STAFF REPORT  
(PRELIMINARY PLAT)

CASE NUMBER: SUB 2003-07 -- FOX RIDGE ADDITION

STAFF REPORT  
(Final Plat, Preliminary Plat Approved 2-13-03)

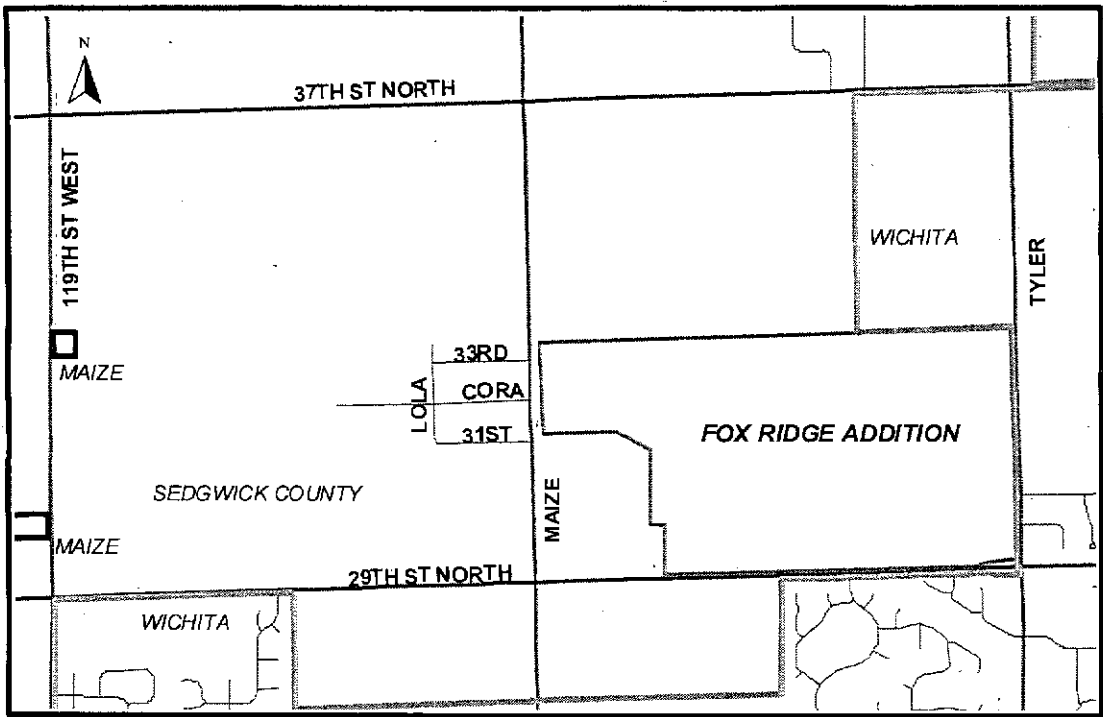
At the March 11 Address Committee meeting, the vote was to unanimously oppose the use of Fox Ridge as a street name in the proposed Fox Ridge Addition. The vote to oppose this street name is based on the following:

- Emergency Services - The concern is the potential for confusion when citizens needing emergency services call Sedgwick County's Emergency Communications (911). When citizens are calling 911 for emergency services, they have a tendency to frantically report the location of their emergency and can occasionally mis-communicate. Emergency services personnel on the Address Committee were concerned about the delay in reporting and relaying the correct information to emergency responders because of its similarity with several other street names that already utilize "Ridge". There are currently 51 street names that currently use Ridge as part of their street name.

- Cora Street Name - Cora is an existing street name that is west of Maize Rd. between 29<sup>th</sup> St. N. and 37<sup>th</sup> St. N. Cora is immediately west of the proposed Fox Ridge Addition and "lines up" with the location for the proposed Fox Ridge street name. As shown in the attached map, Cora would be directly across the street from the proposed Fox Ridge street name.

- Street Names throughout Sedgwick County – GIS records show that 76% of the street names throughout Sedgwick County have a total length of less than 1 mile. The Address Committee is trying to minimize the number of street names throughout Sedgwick County. This would hopefully curtail the tendency to duplicate some version of existing street names and avoid the potential for confusion when citizens need emergency services.

The recommendation of the Address Committee is to replace Fox Ridge with Cora as a street name in the proposed Fox Ridge Addition.
